VALLEY CHILDREN'S HOSPITAL PROFESSIONAL CENTER
FOUNDATION OFFICE PROJECT
1990 EAST GETTYSBURG FRESNO CA, Project

CHANGE ORDER INFORMATION

These drawings are for changes to the previously approved drawings for Valley Children's Professional Center, 1990 East Gettysburg, Fresno, Ca. Previously approved projects include the following:

CORRIDOR REFLECTED CEILING PLAN, OFFICE
FLOOR PLAN, AND DETAILS
Drawing

14K EXTERIOR STAIRS AND LANDING 1/4"=1'-0"

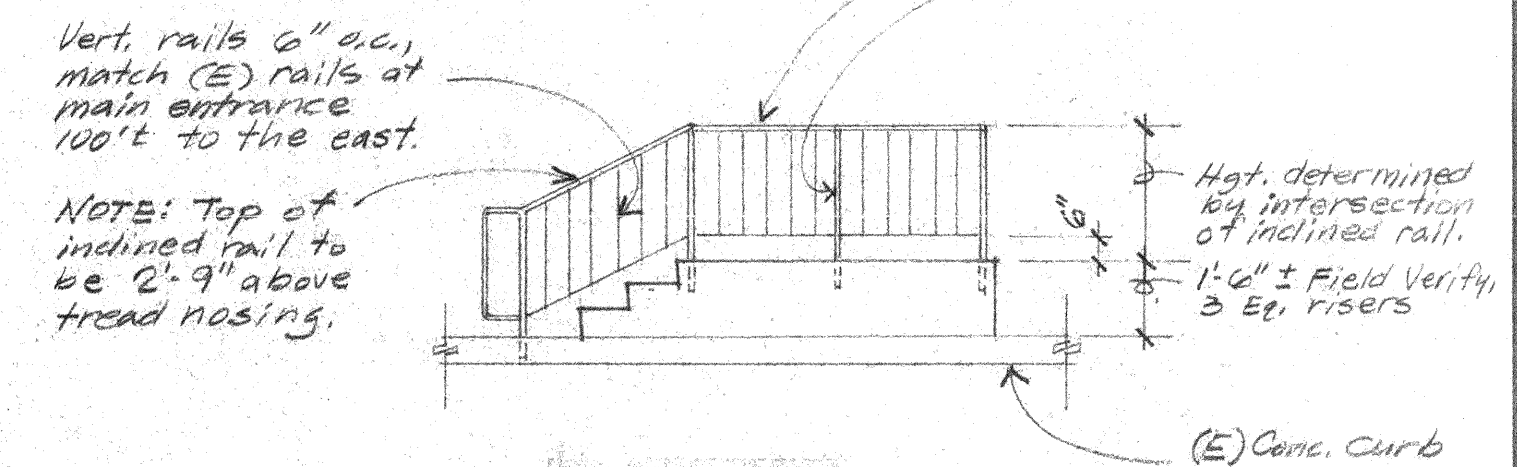
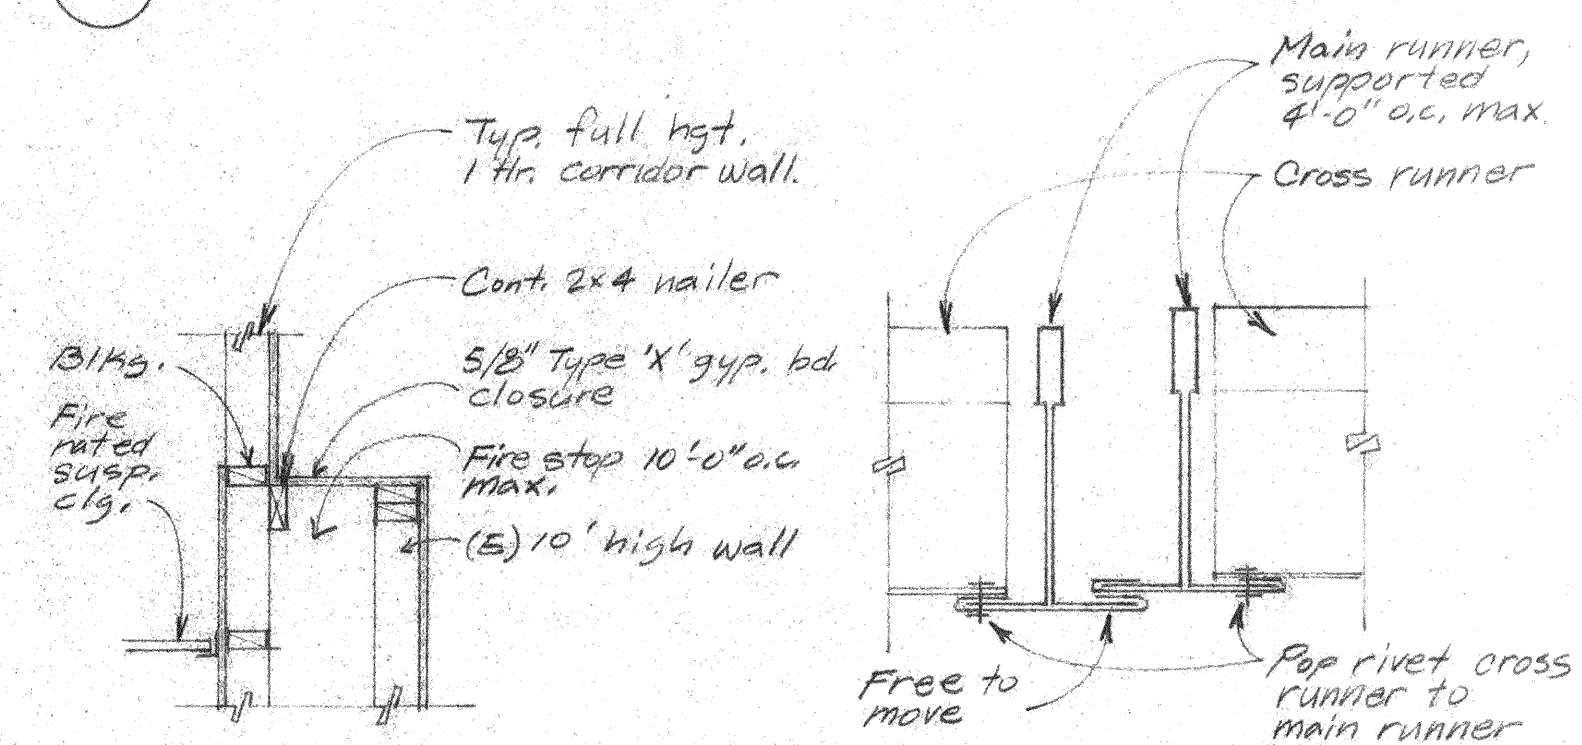
Revisions to landing and handrail. Reference Plan Check #910776, VPC Foundation, Detail 14K/A5. All other notes and details apply.

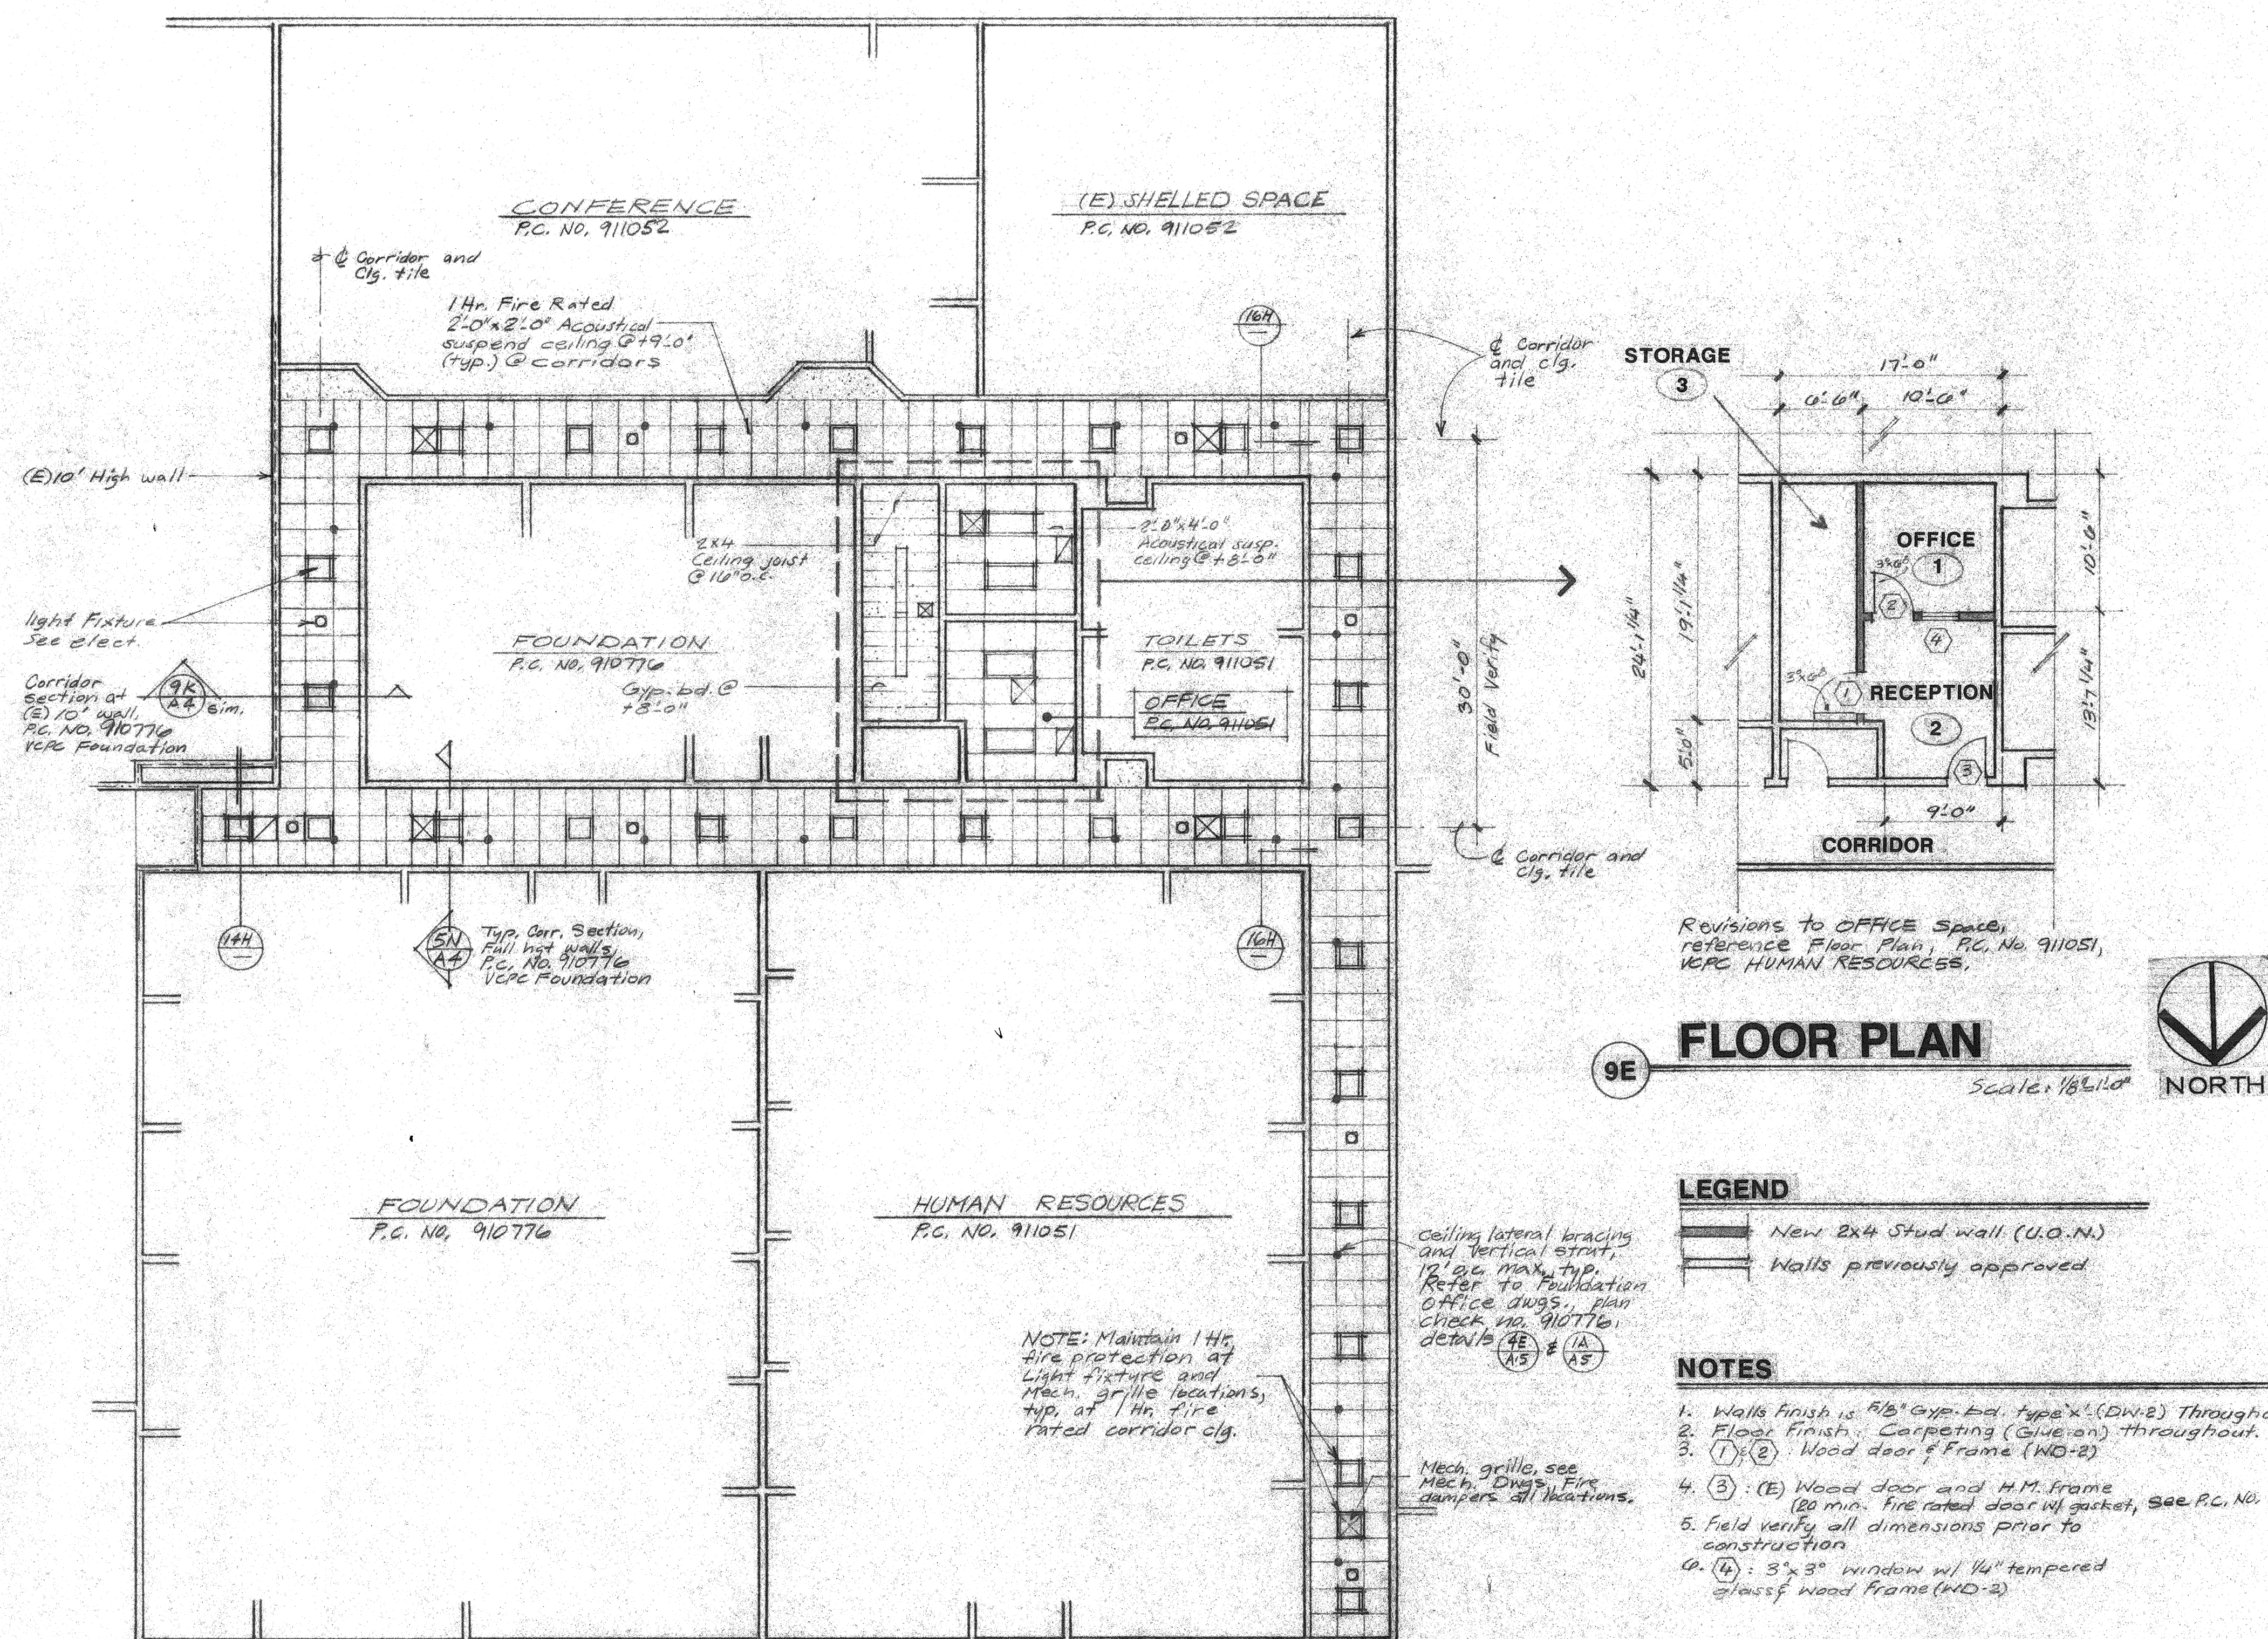
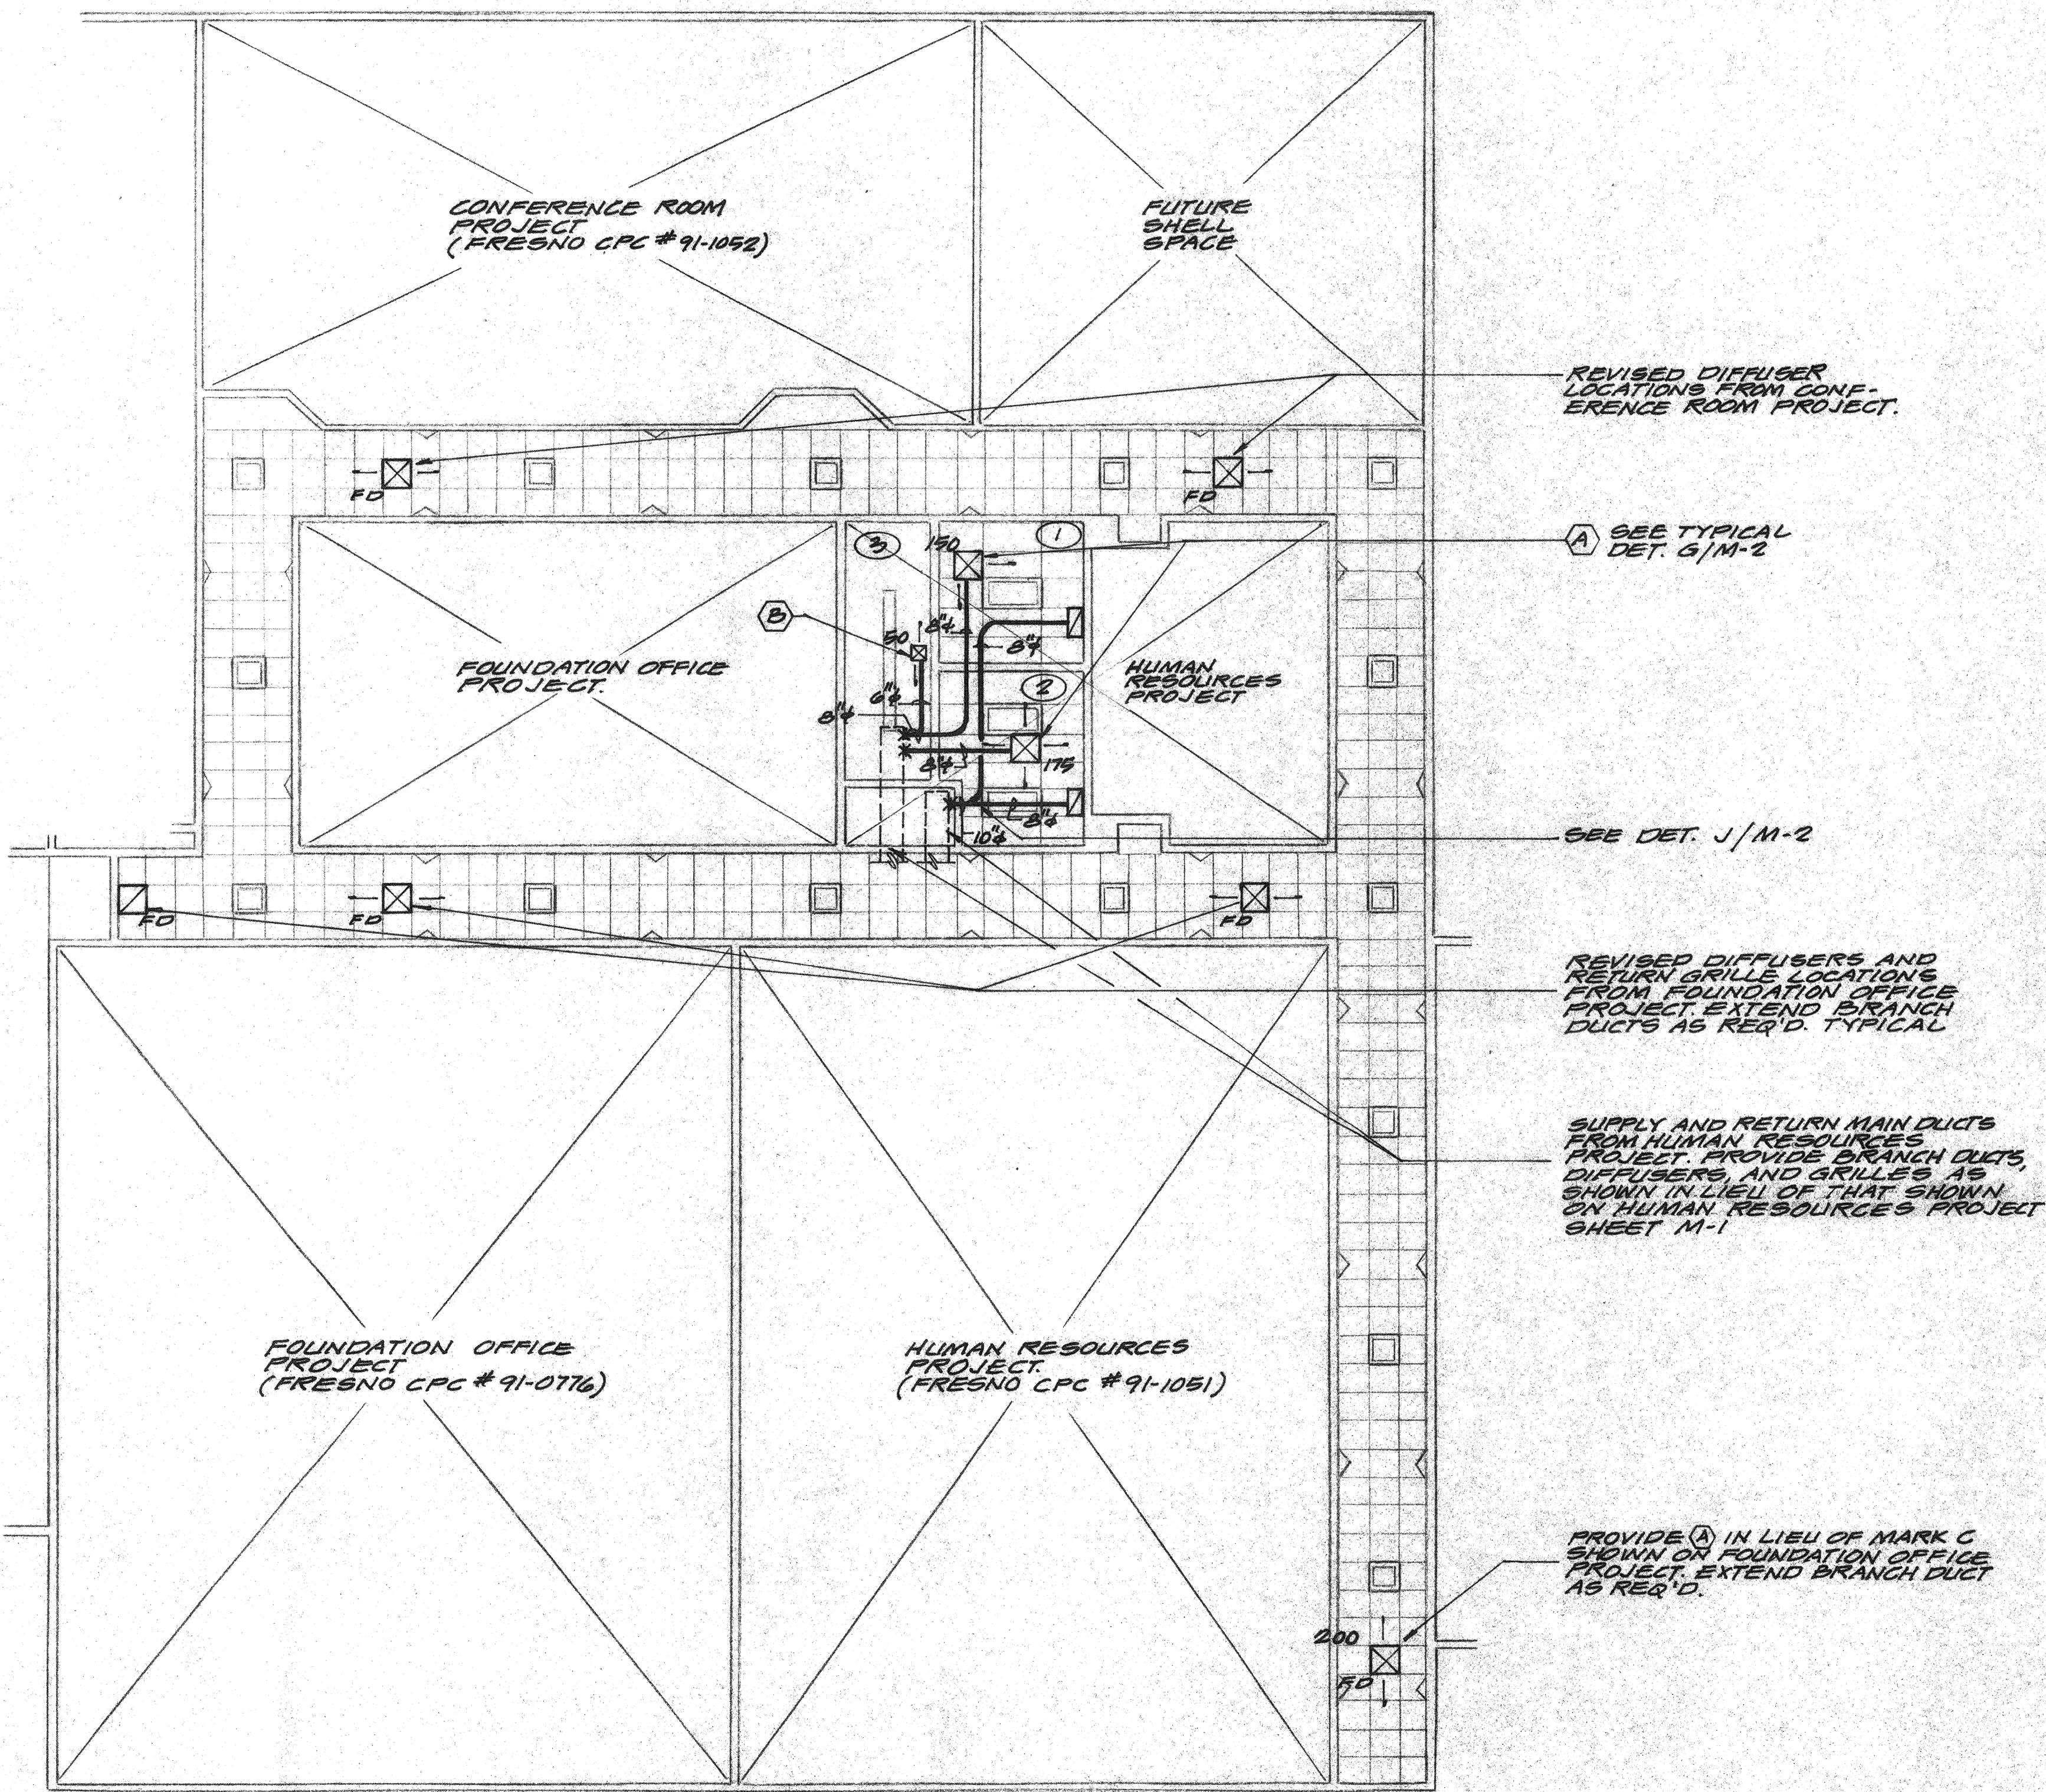
1. Modification of the Corridor cgs., all P.C. Numbers.
2. Modification to the exterior stairs and landing for the Foundation Office Project.
3. Modification to the small office of the Human Resources Office Project.

1. Walls Finish is 5/8" Gyp. bd. Type 'X' (DW-2) Throughout.
2. Floor Finish: Carpeting (Shaw-Wal) Throughout.
3. (1) (2) Wood door frame (WD-2)
4. (3) (E) Wood door and H.M. frame (20 min. fire rated door w/ gasket, see P.C. No. 911051)
5. Field verify all dimensions prior to construction.
6. (4) 3' x 3' window w/ 1/4" tempered glass w/ wood frame (WD-2)
